Add the following variables to 33.3.3.3:

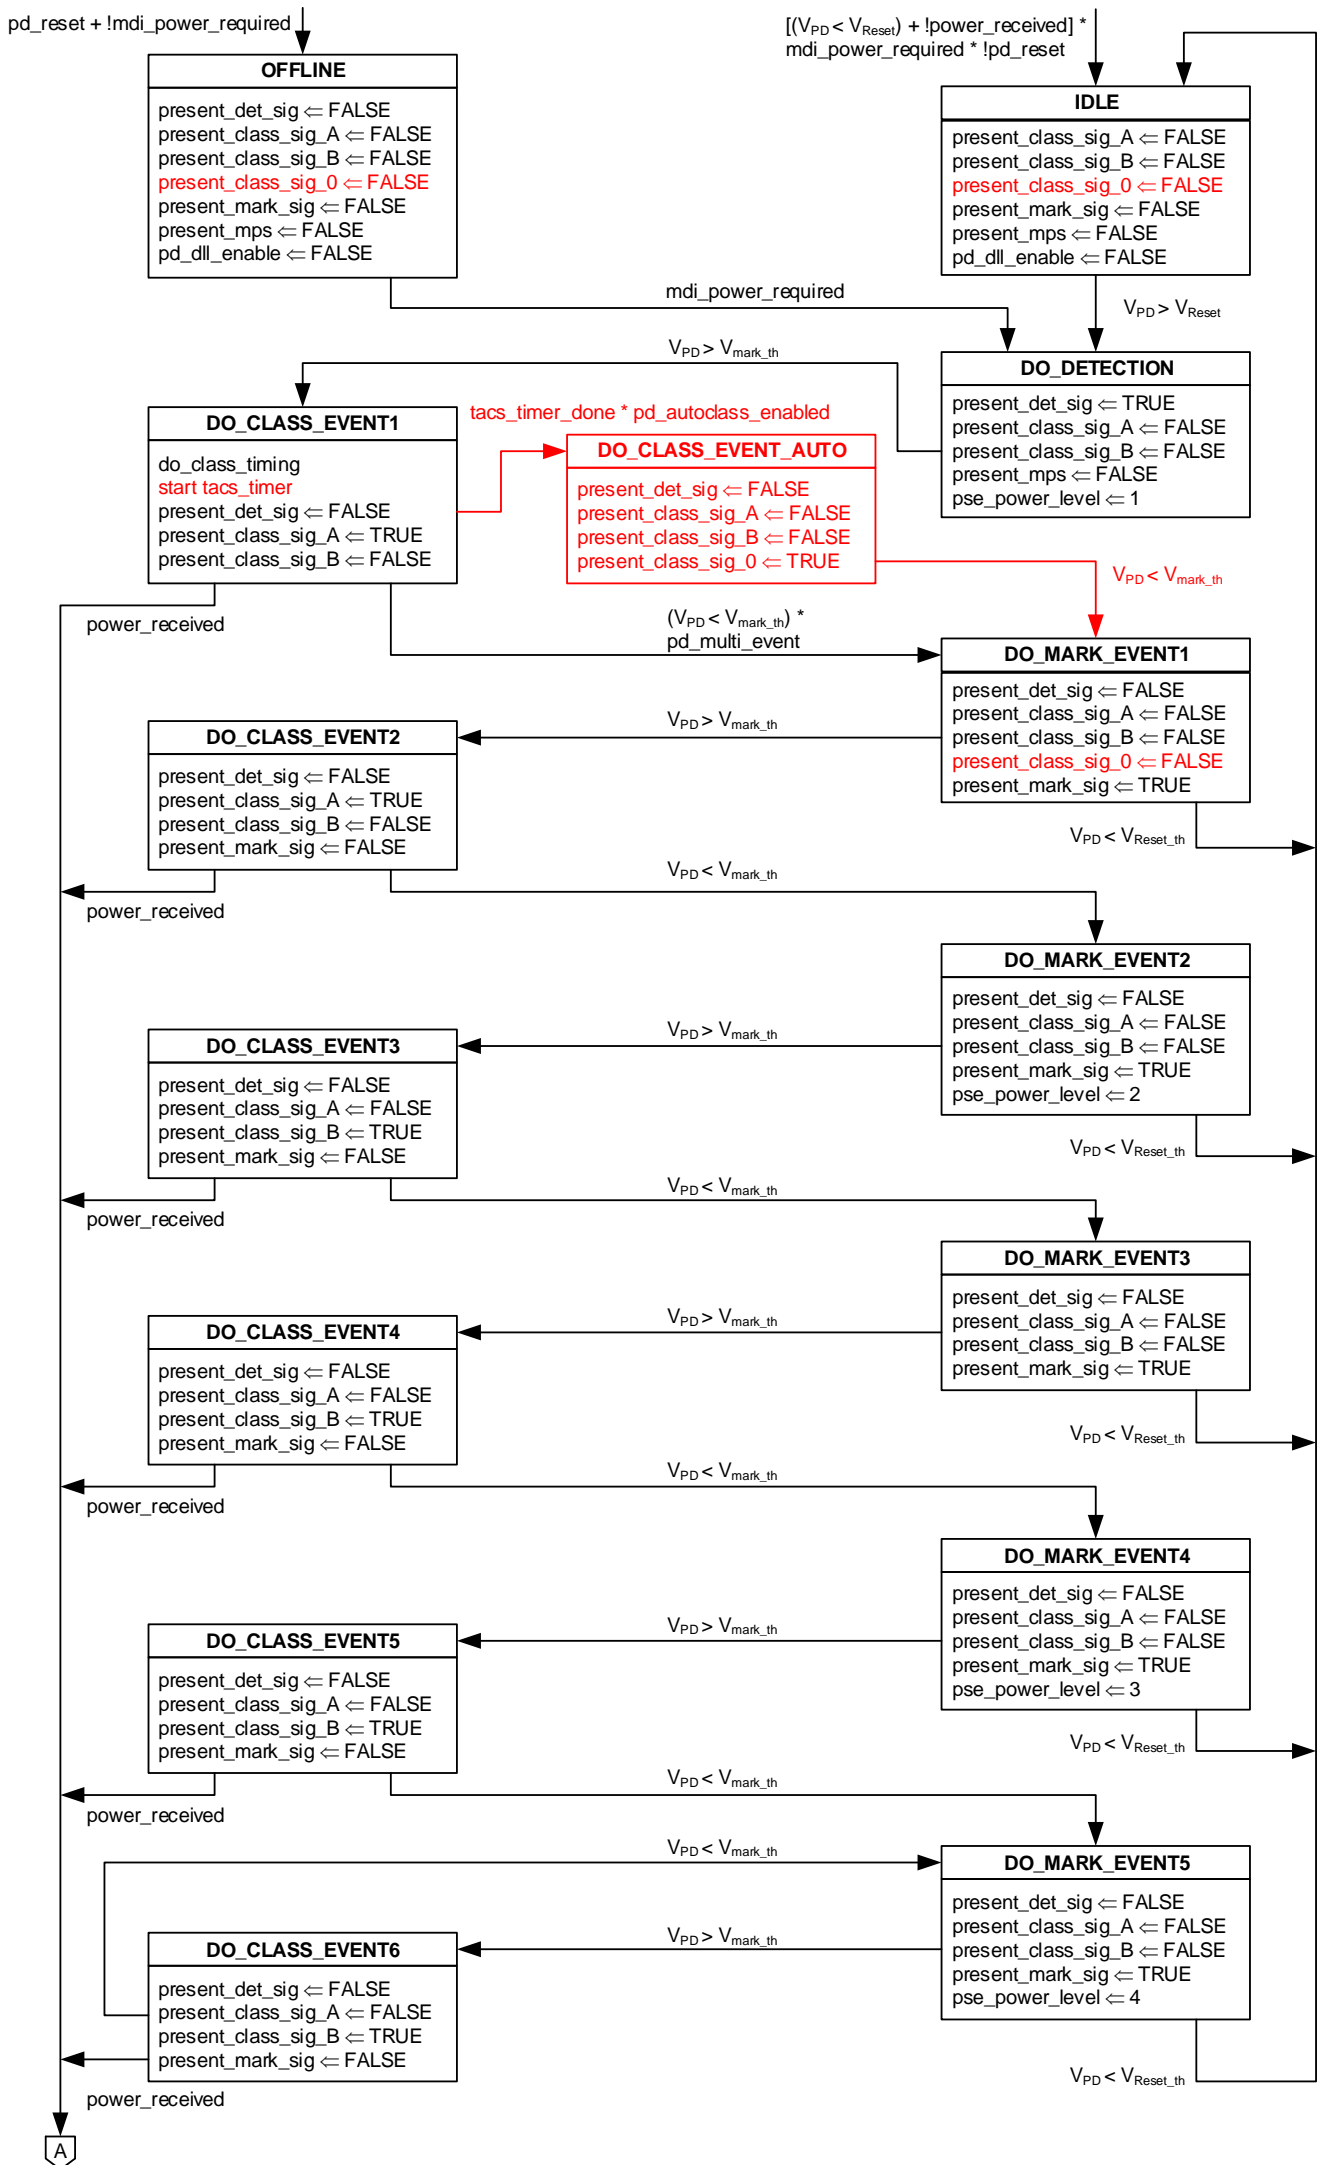
Make the changes to the state diagram as indicated in red on the next page.
